Access Compliance Report

Public Rights-of-Way

(Curb Ramps)

Intersection ID: 12493	Main Street: BELVEDERE_AV	Cross Street: WINTER_ST	Location: NE
ADA ID: DDD0C2528C80	Ramp Type: BlendTrans1	Initial Pass/Fail: Pass	Overall Compliance: No
		Severity Score: 0

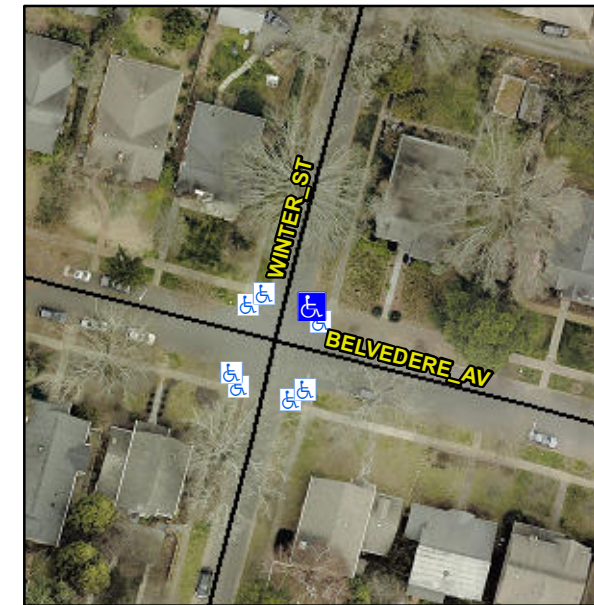
**R304.2.2-Perp, R304.3.2-Para,
R304.5.3**

**Remove & Replace Landing.
Remove & Replace Gutter.**
